ADDENDUM No. 1

ALAMEDA COUNTY PROJECT #901993

RCD SECURITY SCREEN INSTALLATION

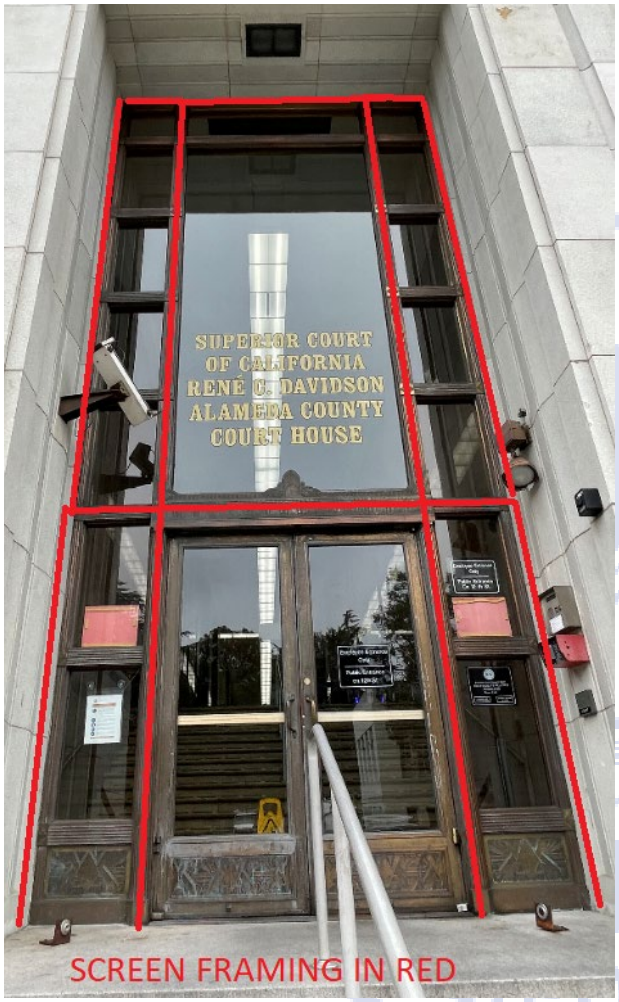
Q17) I can mount the screens directly on the doors, for the 12th street and 13th street entrances, but will need to mount on tube (frames) at the inoperable portions at sides and top (sidelites and transoms) See pictures below. - Please clarify if the county approves.

A17) The County approves mounting the screens directly on the doors, for the 12th street and 13th street entrances, but mount on tubes (frames) at the inoperable portions at sides and tops (sidelites and transoms). Screens shall be sized to leave 2 inches above the window seal to allow for drainage.
